## Technical Service Bulletin

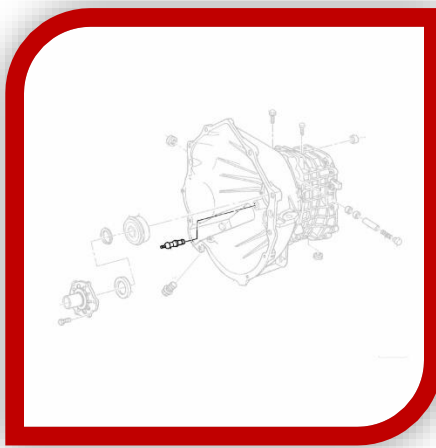
Insufficient lubrication between the fork and the ball stud may be misdiagnosed as a release bearing problem. Light pressure on the clutch pedal will silence the noise temporarily. Lubrication of the pivot ball-to-fork contact will eliminate the problem. To speed up future lubrication, install a grease fitting.

The 1984- S- and T- Series with Borg-Warner 5-speed transmissions (ML2, ML3, MW1) require a pre-drilled pivot ball and matching release fork. Locate the raised boss on the outside of the bell housing that is directly in-line with the center of the pivot ball mounting hole. Drill a hole through the center line of the boss into the pivot ball mounting hole and tap the hole for installation of a 1/8-inch NPT grease fitting. Lubricate the pivot ball and reinstall the transmission with a pipe plug instead of a grease fitting. This will prevent over-lubrication of the pivot stud during normal maintenance.
